To: T10 Technical Committee  
 From: Rob Elliott, HP (elliott@hp.com)  
 Date: 17 November 2007  
 Subject: 07-119r5 SAS-2 Far-end retimed loopback phy test function

**Figure 3 — SP (phy layer) state machine - transitions applicable to all states**

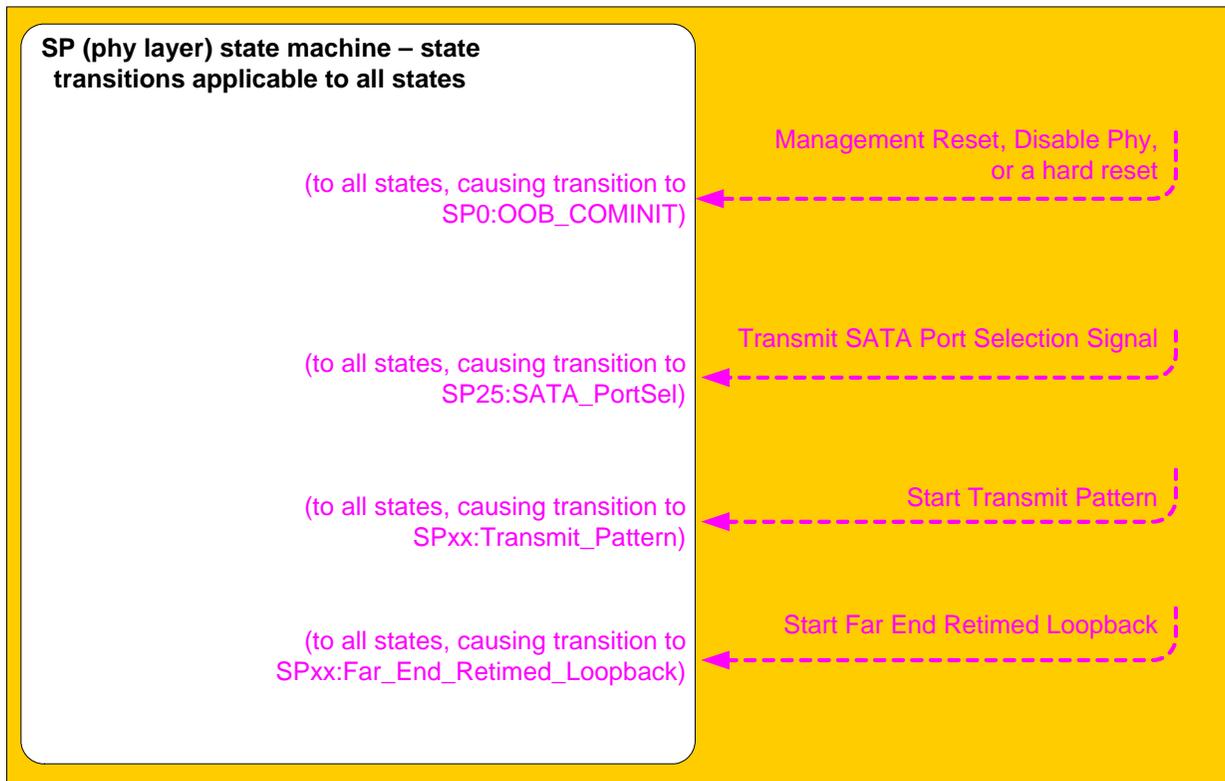
#### **6.8.3.3 Transition to SPxx:Transmit\_Pattern**

This transition shall occur after receiving a Start Transmit Pattern request (e.g., from the SMP PHY TEST FUNCTION function requesting a phy test function of TRANSMIT\_PATTERN in an expander device).

#### **6.8.3.4 Transition to SPxy:Far\_End\_Retimed\_Loopback**

This transition shall occur after receiving a Start Far End Retimed Loopback request (e.g., from the SMP PHY TEST FUNCTION function requesting a phy test function of FAR\_END\_RETIMED\_LOOPBACK in an expander device).

Figure 138 — SP (phy layer) state machine - OOB sequence states [modified]

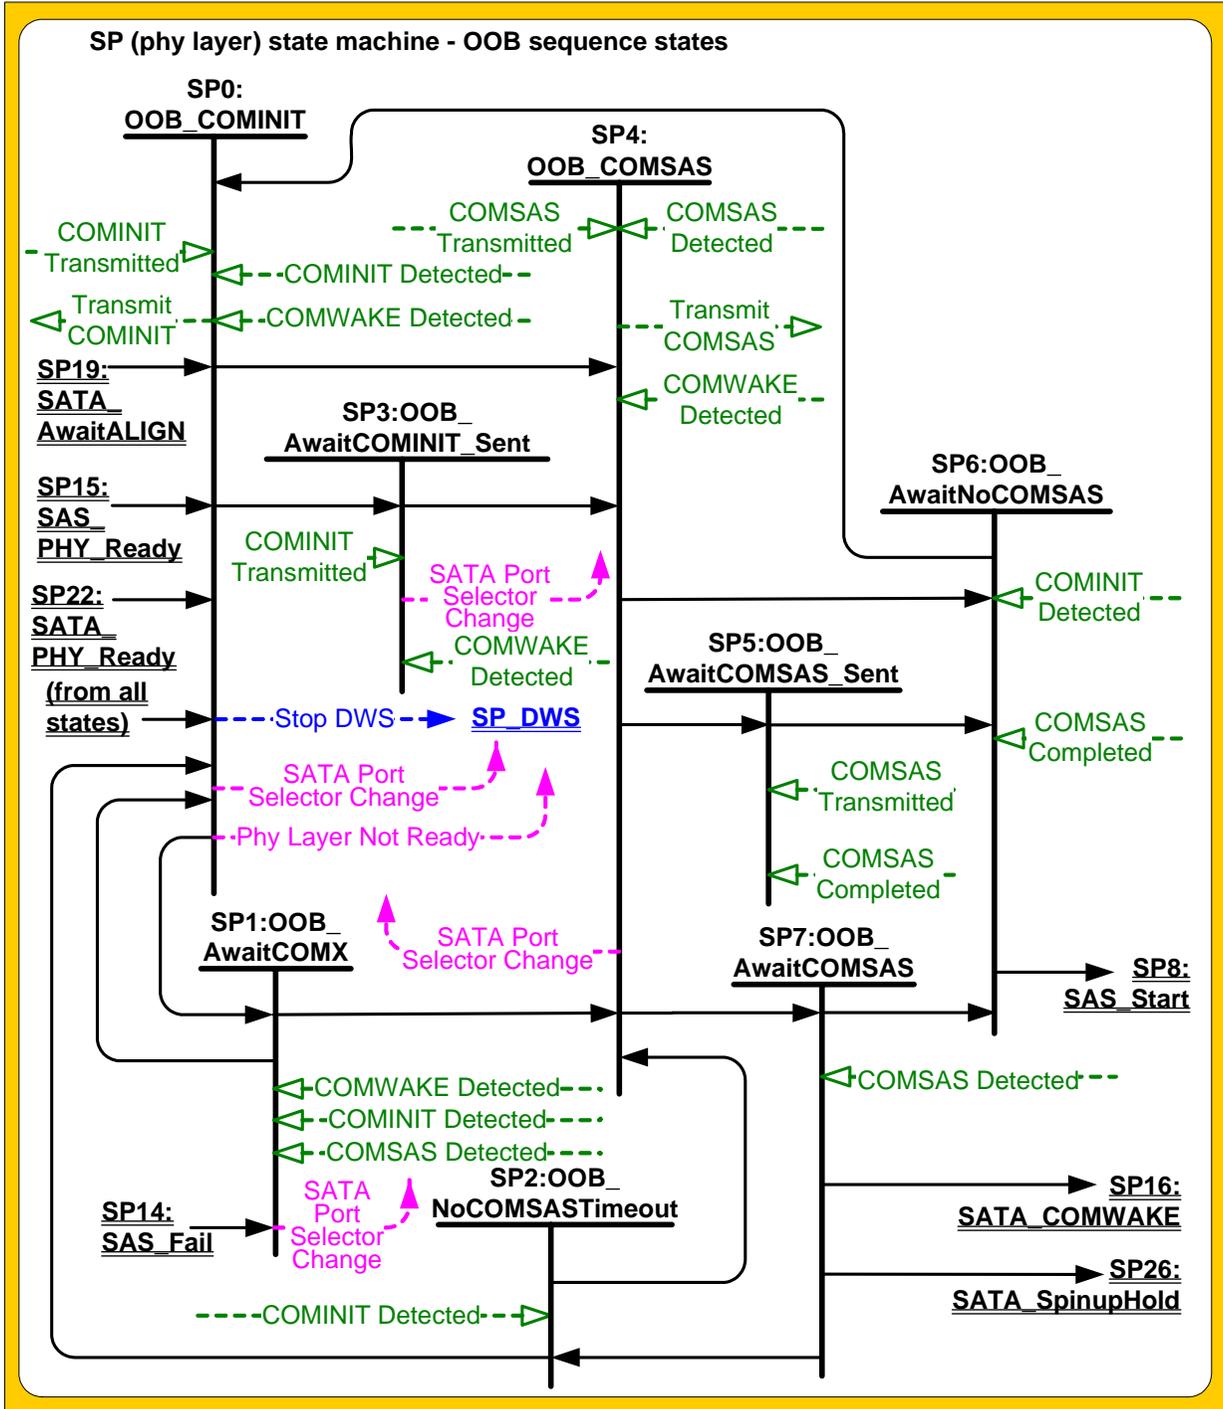
Figure 138 shows the OOB sequence states. These states are indicated by state names with a prefix of OOB.

Figure 139 — SP (phy layer) state machine - SAS speed negotiation states [modified]

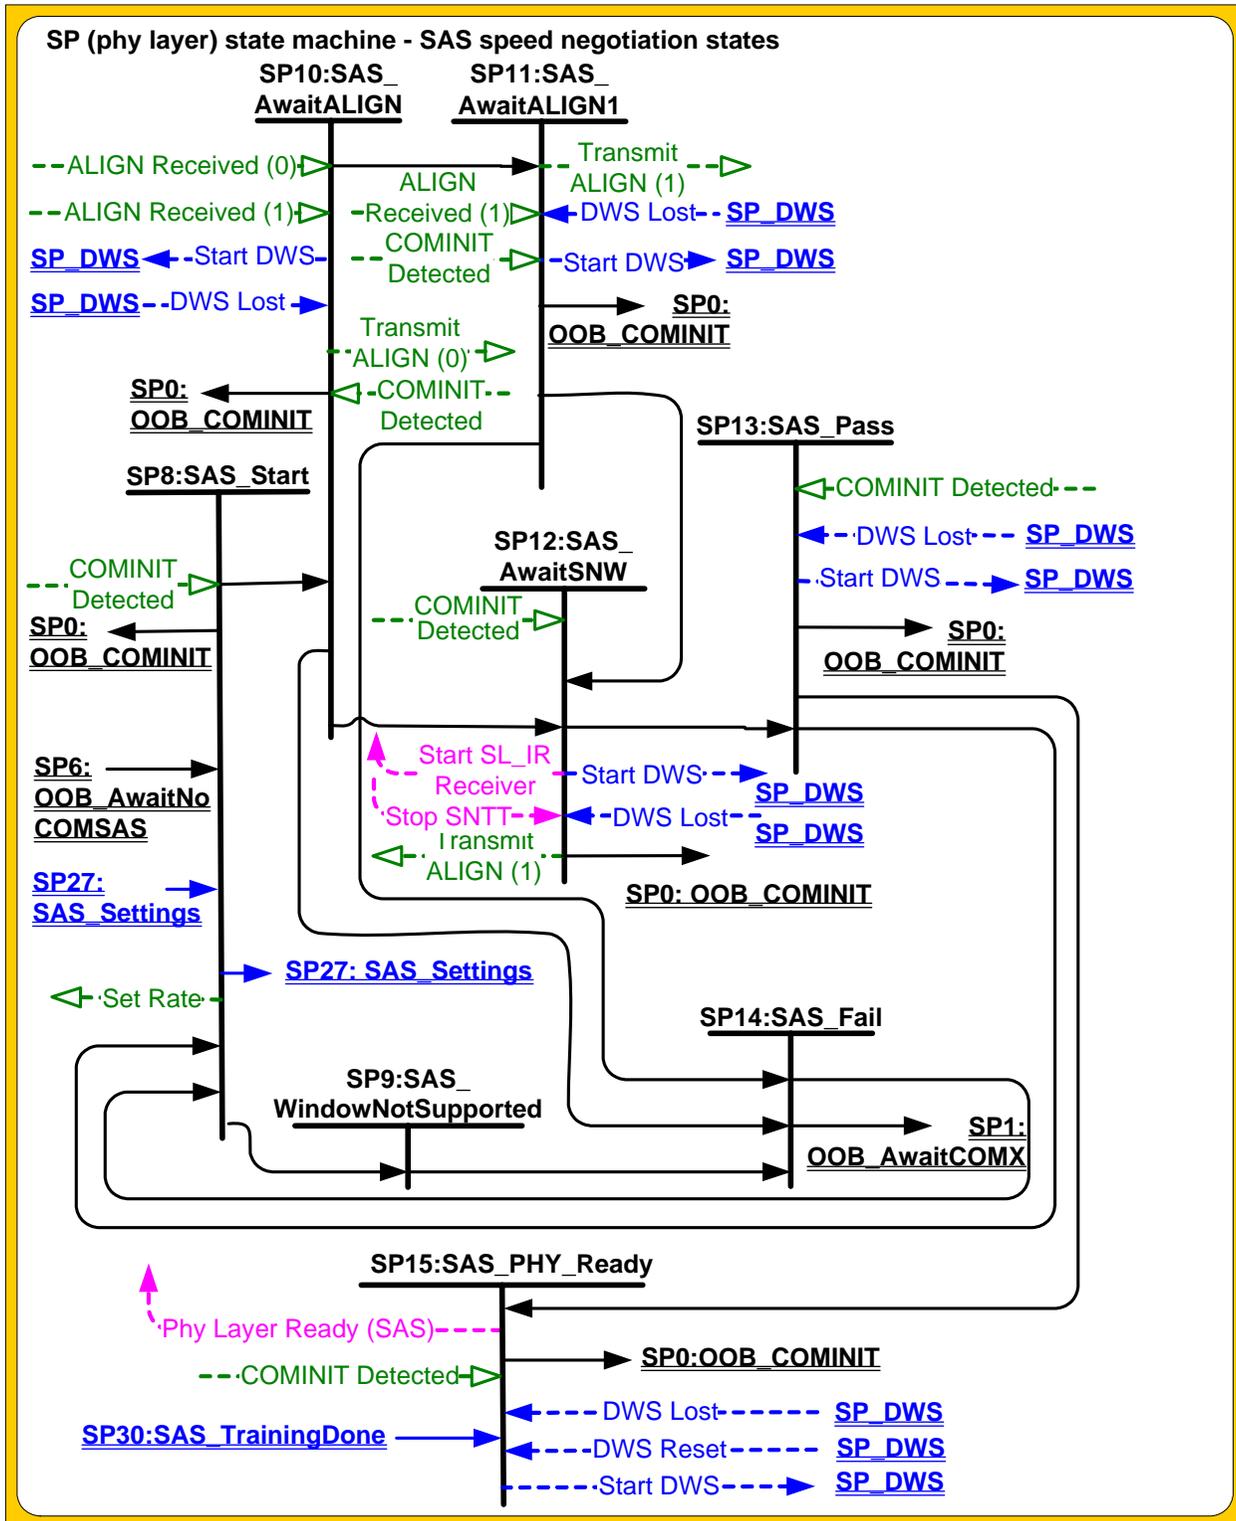
Figure 139 shows the SAS speed negotiation states, in which the phy has detected that it is attached to a SAS phy or expander phy rather than a SATA phy, and performs the SAS speed negotiation sequence. These states are indicated by state names with a prefix of SAS.

Figure 140 — SP (phy layer) state machine - SAS speed negotiation states for SNW-3 and Train-SNW [modified]

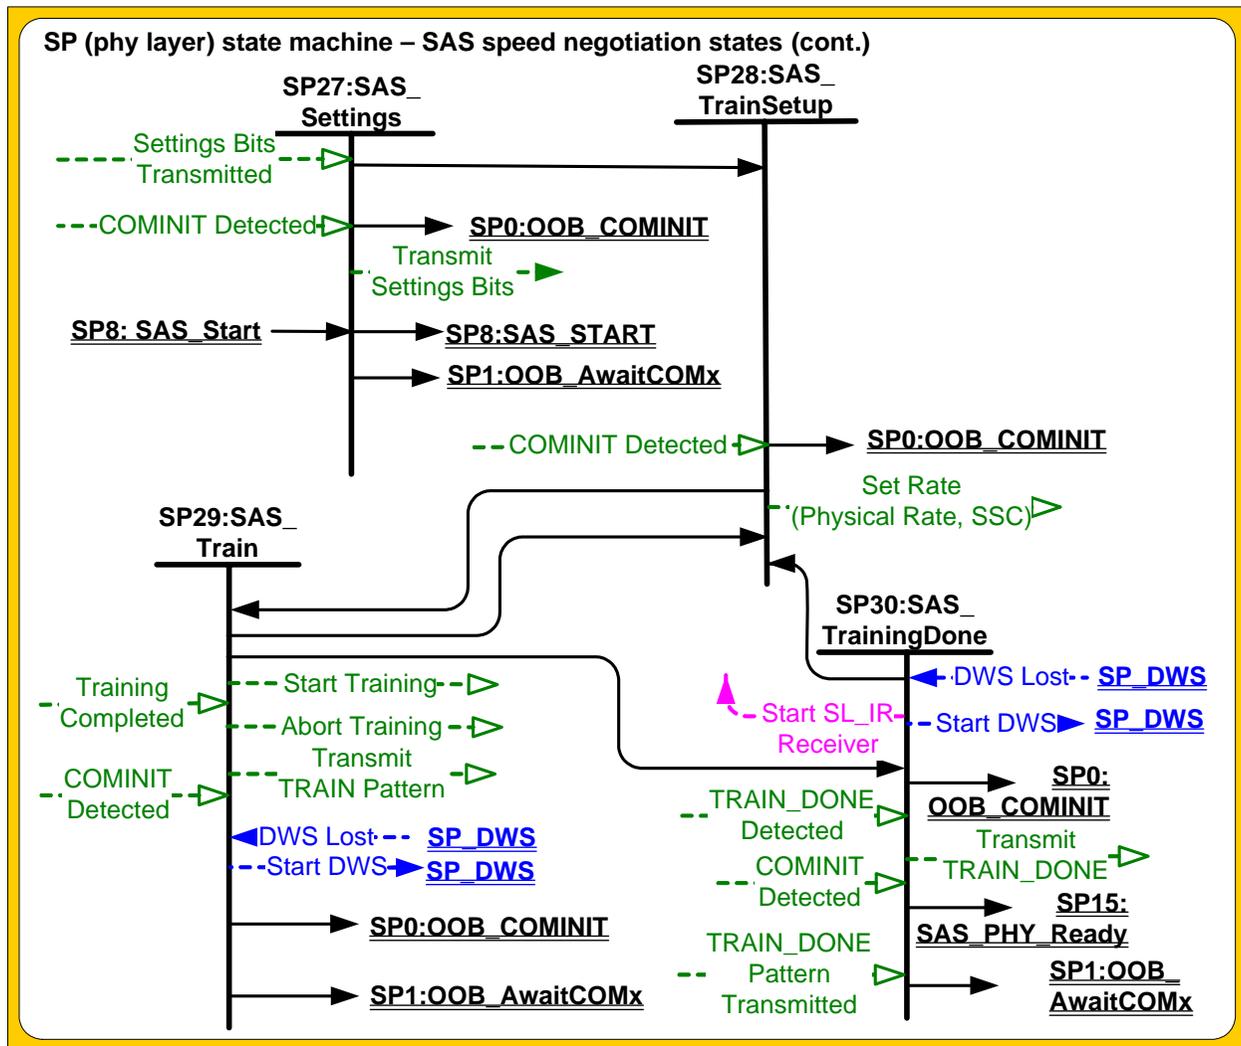
Figure 140 shows the SAS speed negotiation states related to SNW-3 and Train-SNW.

Figure 141 — SP (phy layer) state machine - SATA host emulation states [modified]

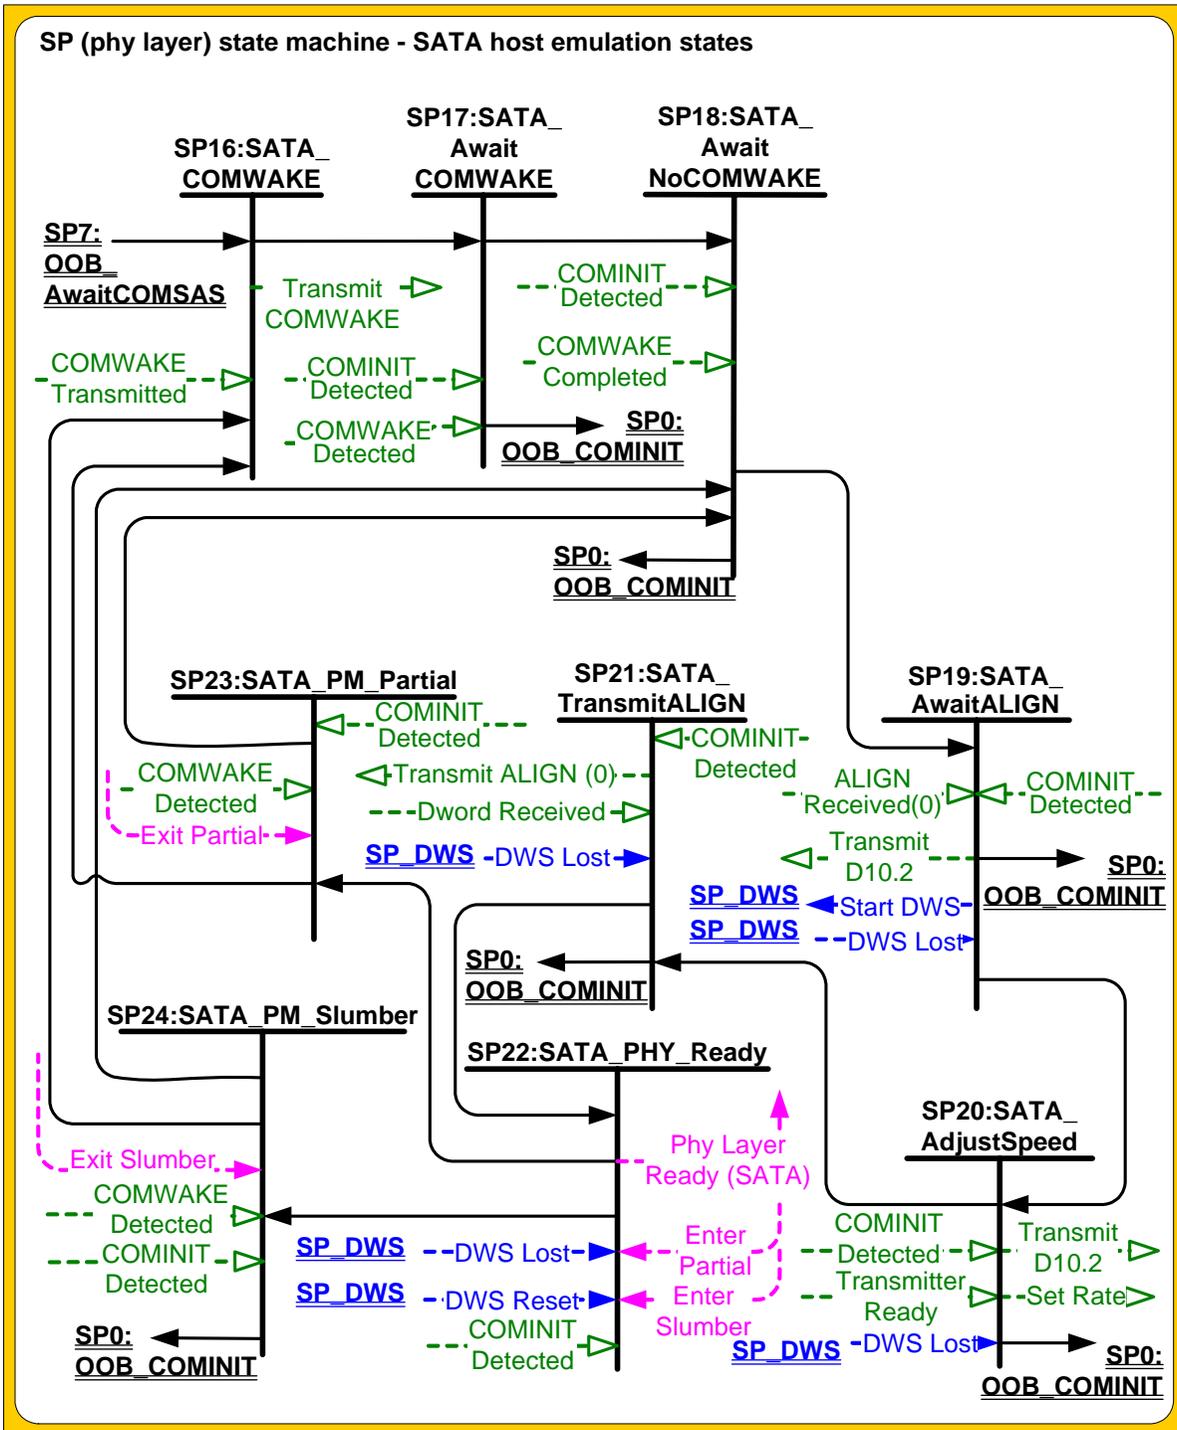
Figure 141 shows the SATA host emulation states, in which the phy has detected that it is attached to a SATA phy and behaves as if it were a SATA host phy, initiating the SATA speed negotiation sequence. These states are indicated by state names with a prefix of SATA.
